# THE MEMPHIS DEPOT TENNESSEE

AR File Number 364

**Final Field Sampling Plan Addendum for Operable Unit (OU) 3**

**DATE:** September 25, 1998

Figure 1  
RI Site 25, Golf Course Pond  
Constituents Exceeding Risk-Based Criteria  
Defense Distribution Depot Memphis, TN

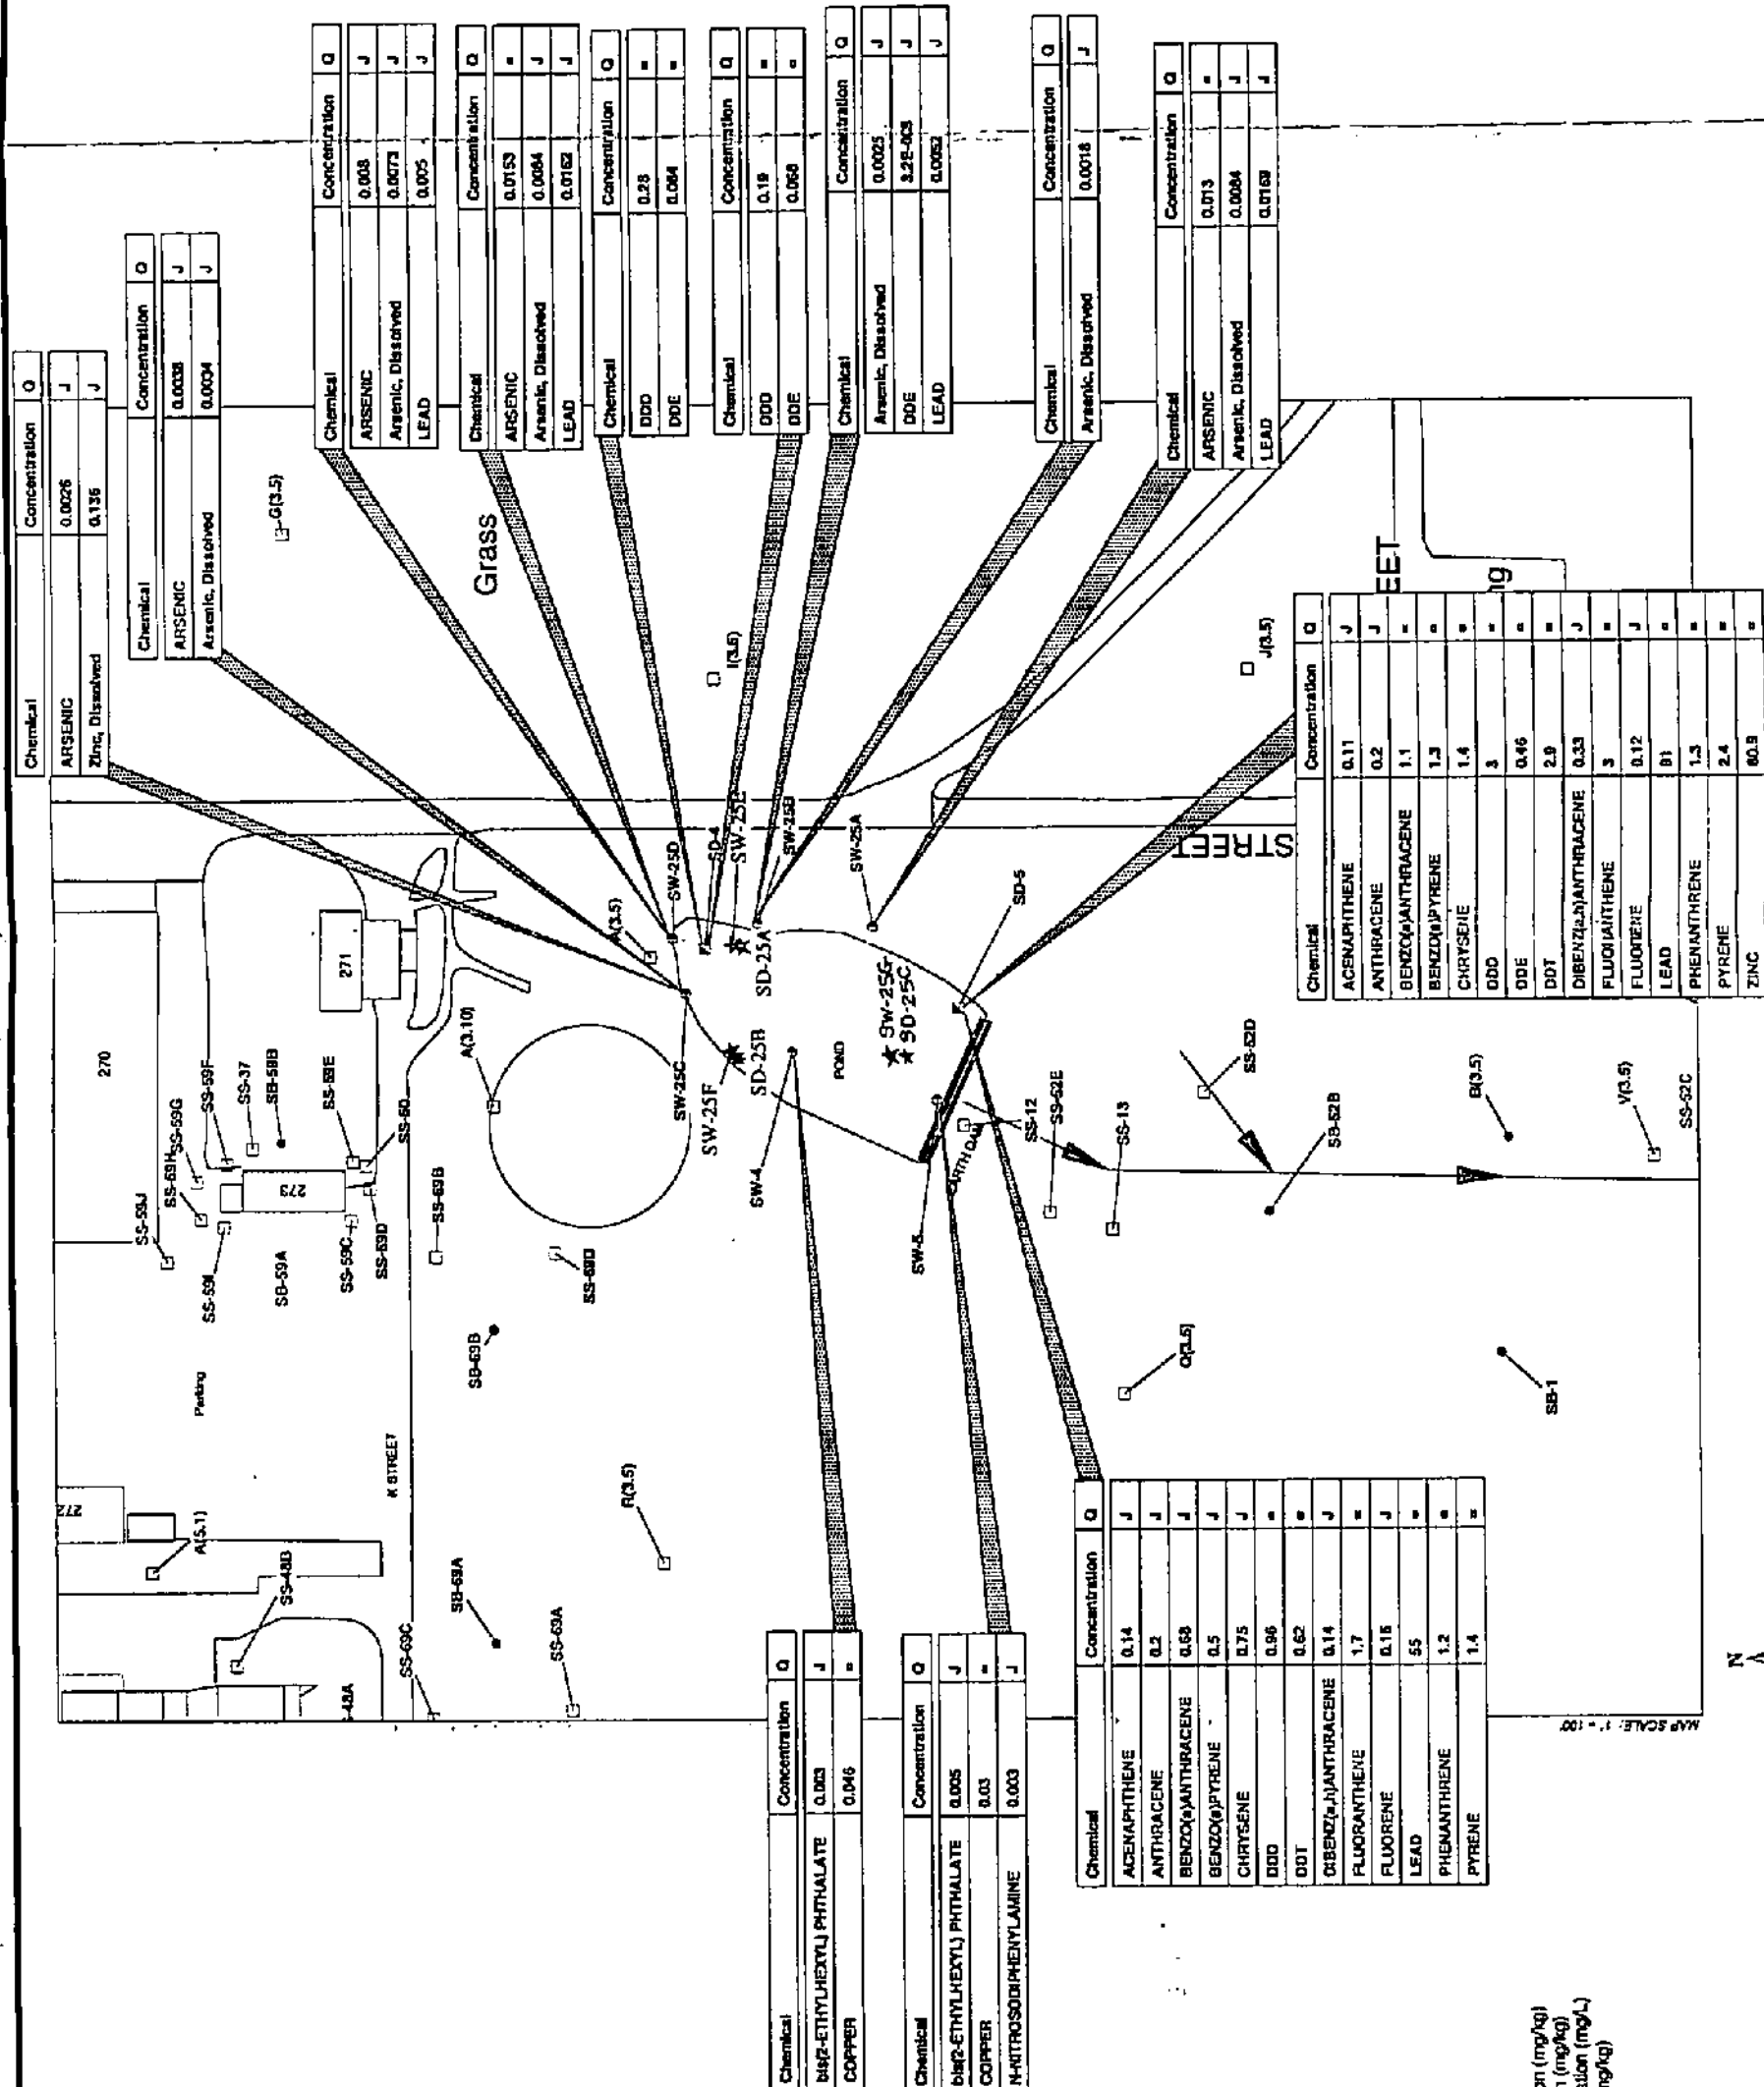
The COPCs identified for RI Site 25 include DDE in the surface water and DDD, DDT, DDE and lead in the sediment samples. To characterize the extent of contamination at the pond, additional surface water and sediment samples are needed to provide a larger data base, and information on current conditions, upon which to base decisions about this site. Two surface water samples (SW25E and SW25F) and two sediment samples (SD25A and SD25B) are will be collected on the northeast and northwest side of the pond. One surface water sample (SW-25G) and one sediment sample (SD-25C) will be collected from the center of the pond. The samples will be analyzed for target analyte list/target compound list (TAL/TCL) compounds (Table 1) which would be associated with the carrier compounds for pesticides and possible metals associated with these compounds. See Figure 1 for the location of the new samples.

**Figure 2**  
**RI Site 26, Lake Danielson**  
**Constituents Exceeding Risk-Based Criteria**  
*Defense Distribution Depot Memphis, TN*

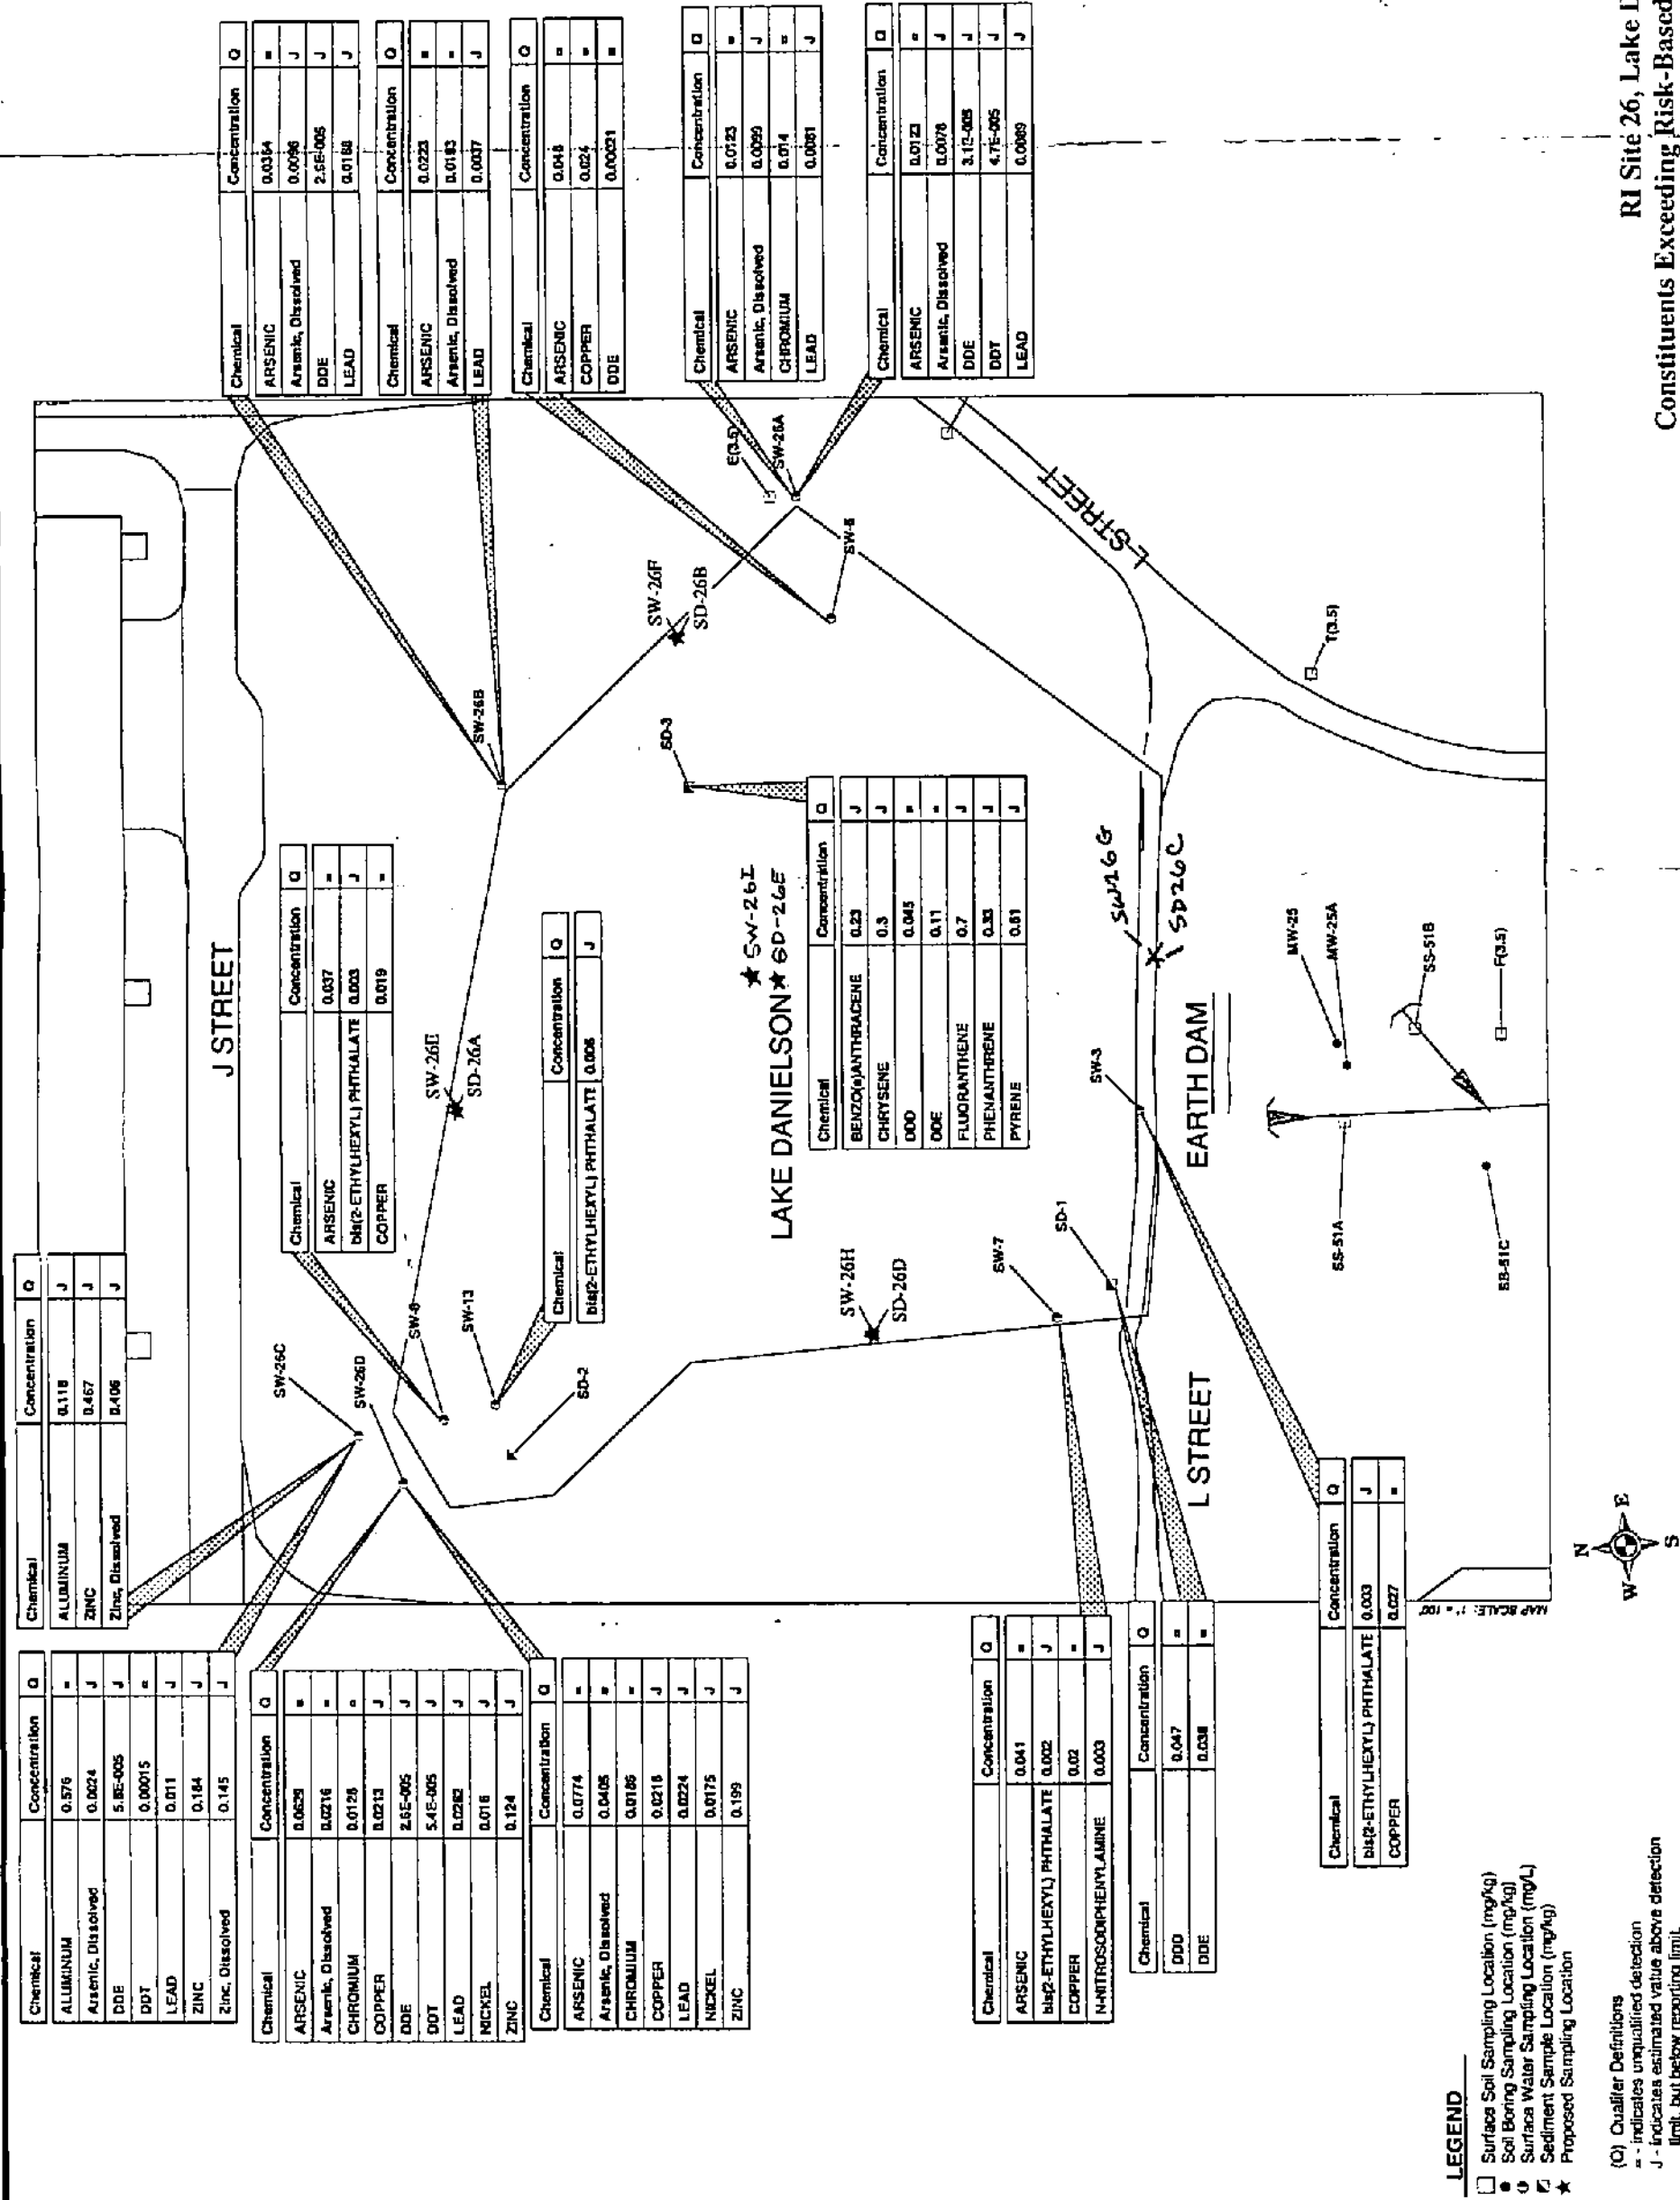
The COPCs identified for RI Site 26 include arsenic, dissolved arsenic, DDE, DDT, lead and zinc in surface waters. Elevated concentrations of DDD, DDT, DDE and other pesticides were detected in the sediments. Additional surface water and sediment samples are needed to characterize the extent of contamination at the site and to provide a larger data base, and information on current conditions, upon which to base decisions about this site. Four surface water samples (SW26E through SW26H) and four sediment samples (SD26A through SD26D) will be collected along the northern, eastern, southern, and western shoreline of Lake Danielson. One surface water sample (SW-26I) and one sediment sample (SD-26E) will be collected from the center of the lake. The samples will be analyzed for TAL/TCL compounds (Table 2) which would be associated with the carrier compounds for the pesticides and possible metals associated with these compounds. See Figure 2 for the location of the new samples.

Figure 3  
RI Site 58, Pad 267  
Constituents Exceeding Risk-Based Criteria  
Deferre Distribution Depot Memphis, TN

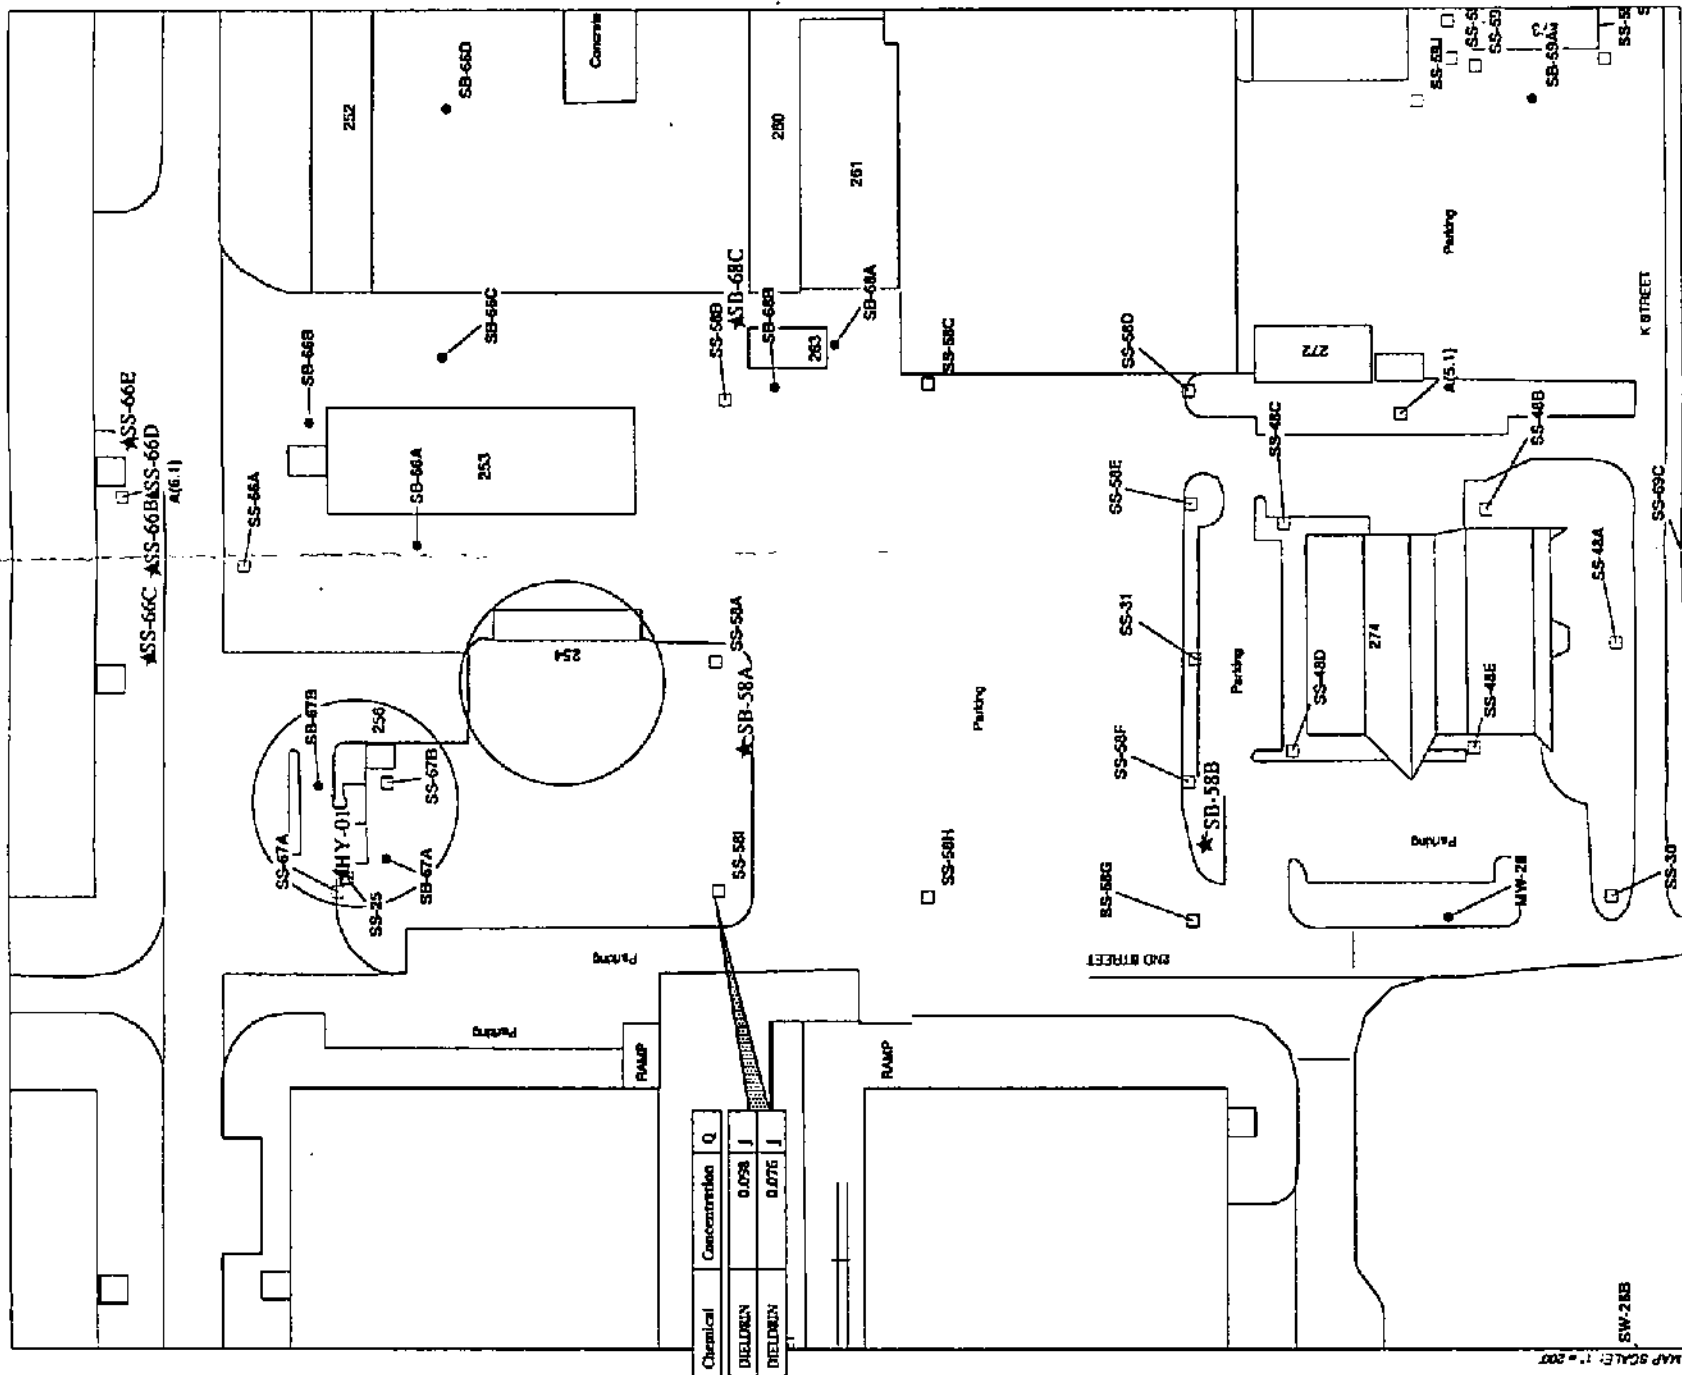
Previously, nine surface soil samples were collected around the former pesticide storage area. Dieldrin was the only contaminants of potential concern (COPC) identified in the samples. Two additional borings (SB58A and SB58B) will be taken to characterize the vertical extent of contamination at the site. The borings will be located between the previous surface soil sample locations. Three samples will be collected from each boring at

depths of 0 to 1 ft, 2 to 5 ft and 8 to 10 ft and will be analyzed for TAL/TCL compounds (Table 3). See Figure 3 for the new boring locations. Existing data for this site does not include broad enough analytical suites to assess whether or not carrier compounds for the pesticides or other possibly associated metals are present at the site.
